SUBJECT: Withdraw of the November 16, 2015 Application for Modification, AND Application for Modification with Additional Information for Section 404 Individual Permit and Section 401 Individual Water Quality Certification for the US-74 Monroe Connector/Bypass in Union and Mecklenburg Counties. STIP R-3329 and STIP R-2559, Division 10, Debit WBS Element 34533.1.TA1 in the amount of \$570.

Reference: US Army Corps of Engineers (USACE) 404 Permit issued May 8, 2015; Action ID: SAW-2009-00876
NC Division of Water Resources (NCDWR) 401 Water Quality Certification Permit issued March 6, 2015; NCDWR Project No. 02-0672 V3

The North Carolina Department of Transportation (NCDOT) is in the process of constructing the Monroe Connector/Bypass, as authorized by the USACE and NCDWR as referenced above. NCDOT is requesting a permit modification for ten Permit Sites: 3, 5, 29, 30, 37, 46, 47, 48, 54, and 57, which are detailed below. Two other sites, 6 and 60, have revisions in jurisdictional areas that do not require a permit modification (see below).

Permit Site 47 (Revised Permit Drawings 183 and 184 of 267):

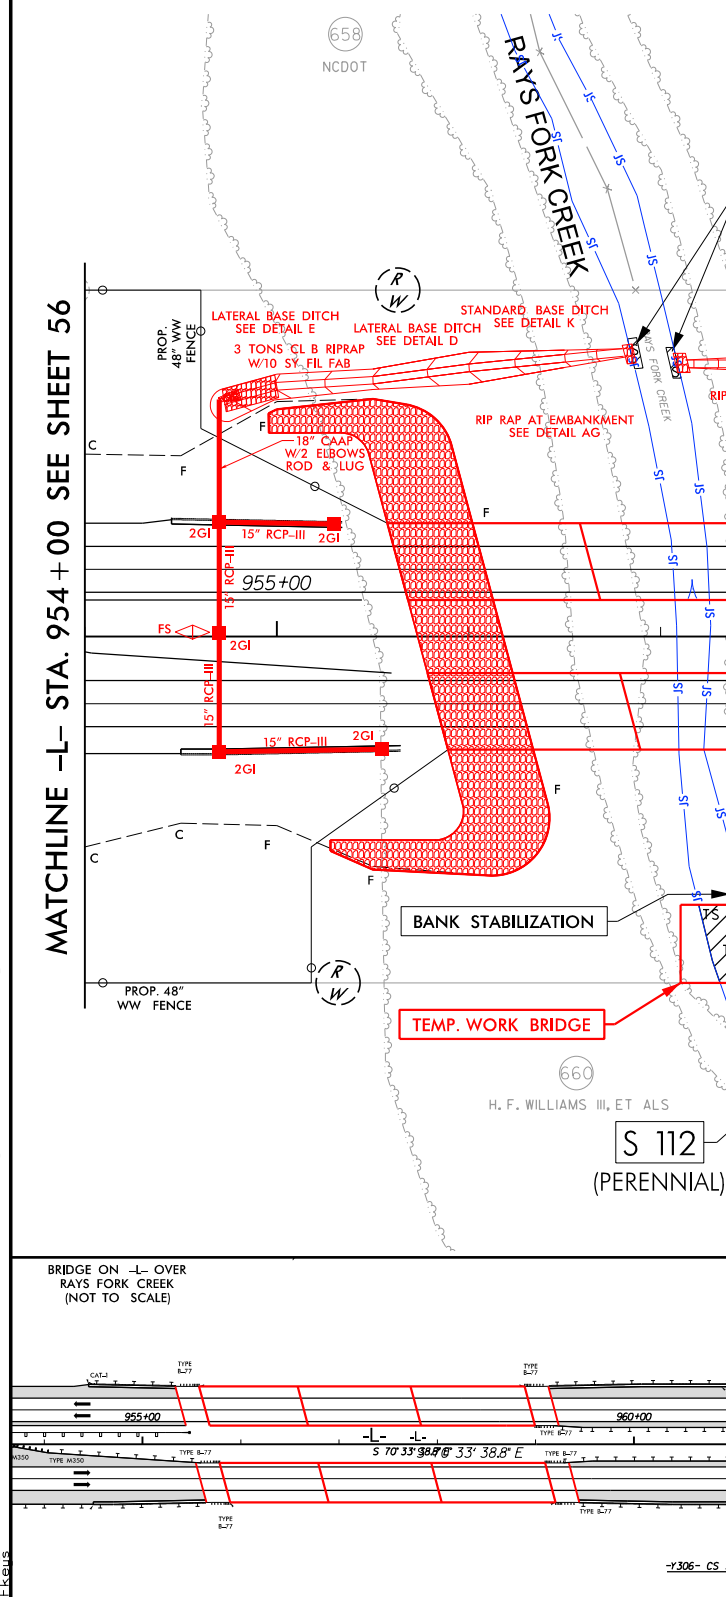
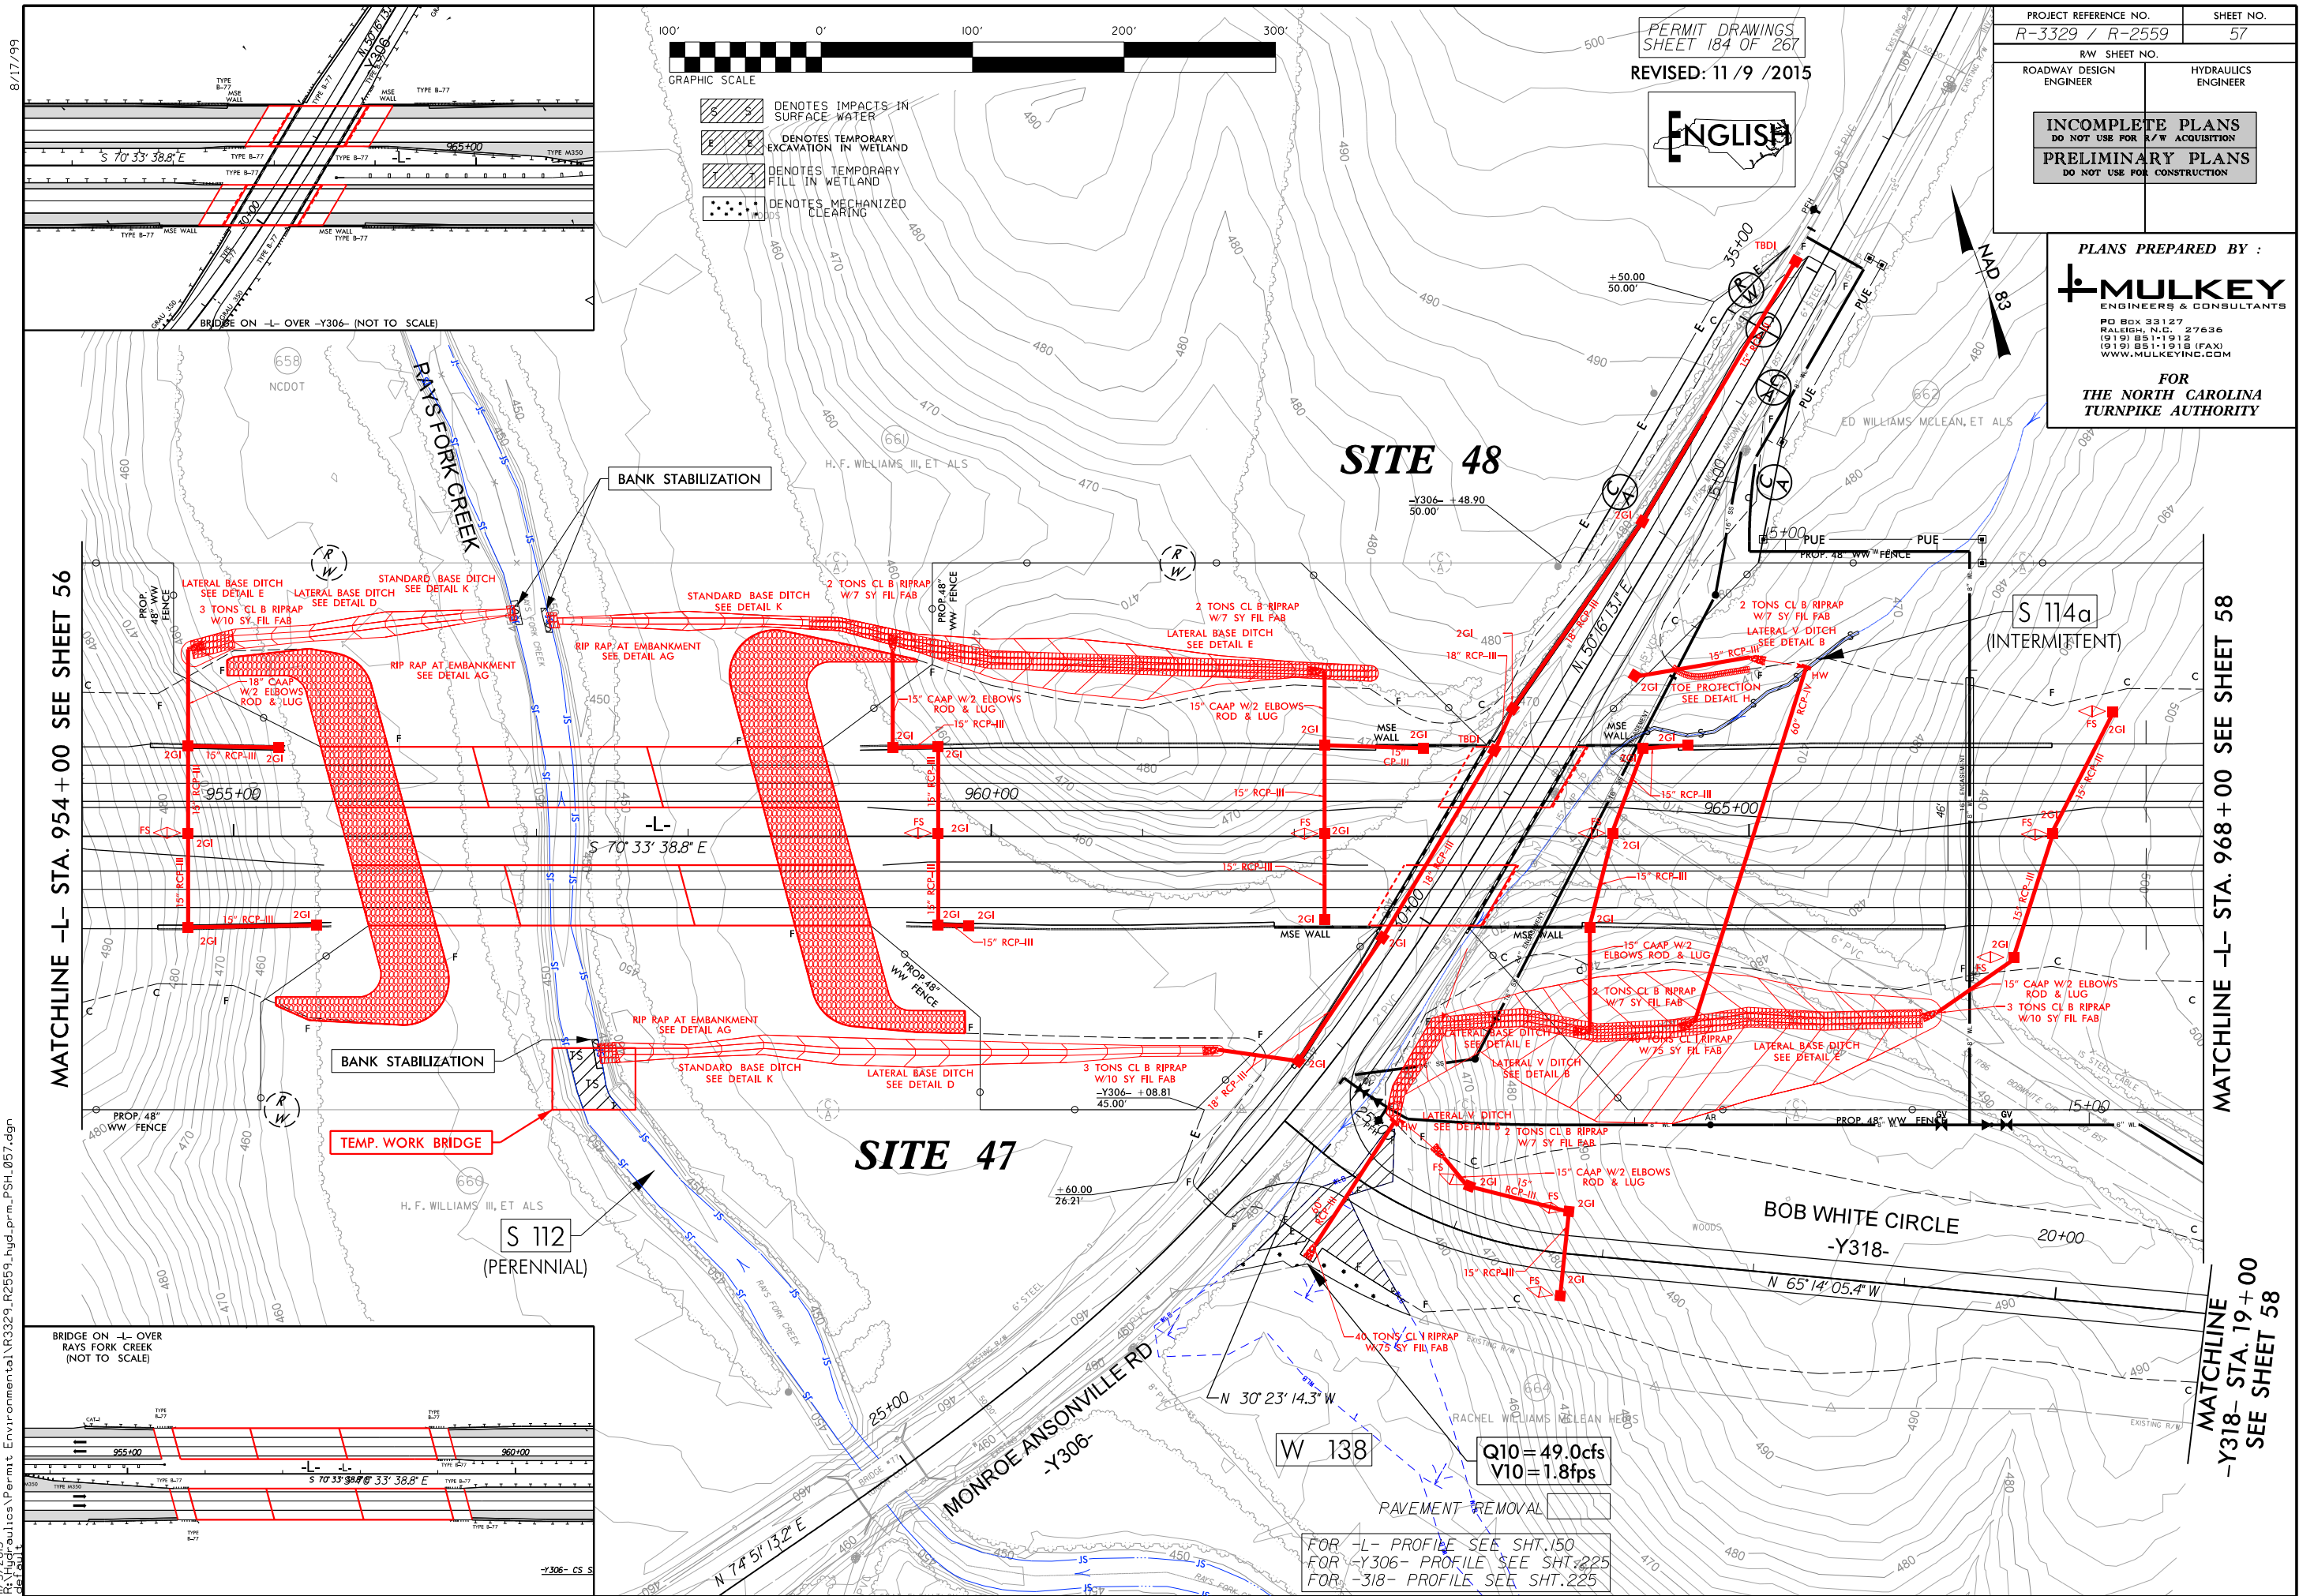
This is the bridge crossing of Rays Fork Creek (S112). The construction of a spanning bridge was permitted to impact 43 lf (<0.01 ac) of stream for bank stabilization. Those permanent impacts have not changed.

As you are aware from our correspondence on August 21, 2015, in order to improve construction access, and expedite construction in jurisdictional areas, the contractor has established a temporary bridge crossing of Rays Fork (Permit Site 47). Please note that this was inadvertently referred to this as Permit Site 48 in the August 21, 2015 correspondence. The bridge details are attached (60 Foot Standard Temp Bridge Detail).

Impacts to Rays Fork were avoided, as the bridge abutments were kept approximately 10 feet away from the top of bank.

While impacts are still not anticipated, it is requested that **30 linear feet (lf) (0.02 acre) of temporary stream bank stabilization be authorized** in the scenario that stream bank destabilization impacts occurs during construction or bridge removal. Any bank stabilization measures will be removed and the area revegetated upon completion of construction.

During the relocation of the sanitary sewer utility, two minor impact revisions occurred:

1. The fill slope had to be slightly altered, as such what was initially going to be 0.01 acre of temporary fill became permanent fill, **increasing that total from 0.06 to 0.07 acre.**
2. **There will be 0.01 acre of temporary excavation in wetlands** to install the utility line. The area will be revegetated with native vegetation upon completion.

This impact is shown in blow up revised permit drawing 183 of 267.
